Fire Risk Assessment 24-27 Vivian Comma Close Version 4

9 October 2023

Review Date: 9 October 2024 Score: Substantial Risk Assessor: Mark Thomas

Alternative exit to second floor balcony of 16-23 Vivian Comma Close

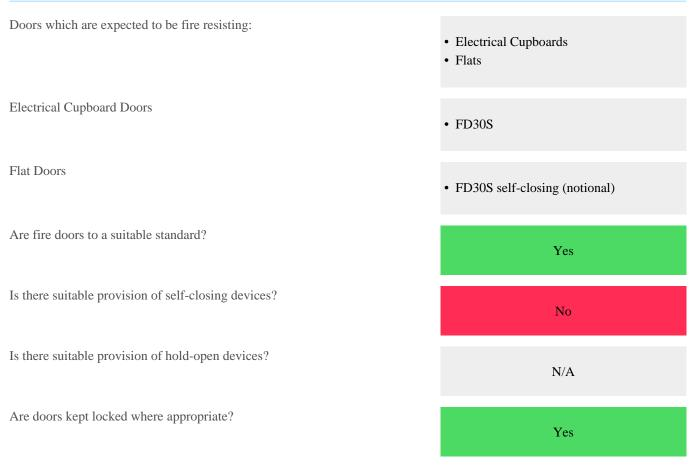
There are a small number of items located in the common areas, which whilst currently do not present a significant risk, these areas should be monitored to ensure they do not build up.

Please see "Detection and Alarm" section of this report, regarding the provision of suitable and sufficient fire alarms to ensure early warning of fire in this building, given the extra care needs of the residents.

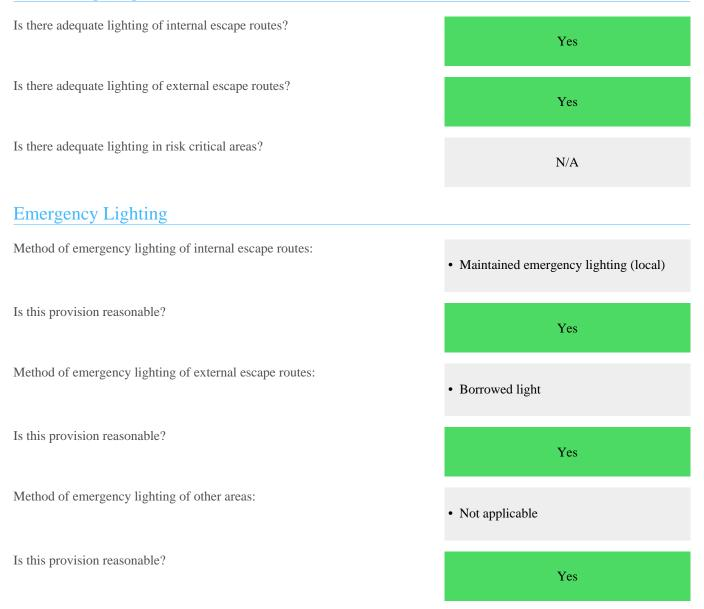
Fire extinguishers are located in the wardens office which is remote from the building for use by staff only and are not accessible by residents.

The provided Fire Action Notice.

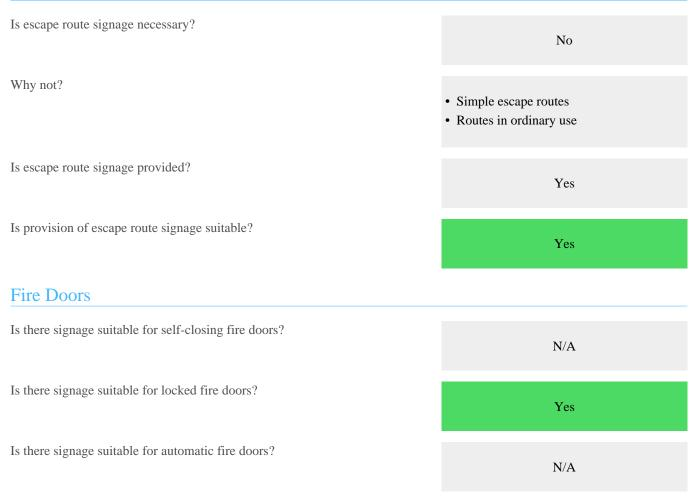
The provided fire action is for a simultaneous evacuation policy- the fire action notice should reflect the stay put policy that is recommended in this building.

Source Version	1	-
Category	Signs & Notices	
Sub Category	Other Signage	O Fire Ac
Action Required	The provided fire action is for a simultaneous evacuation policy- the fire action notice should reflect the stay put policy that is recommended in this building.	
Priority	Medium	
Status	Identified	
Owner	Neighbourhood Services	
Due Date	28 January 2021
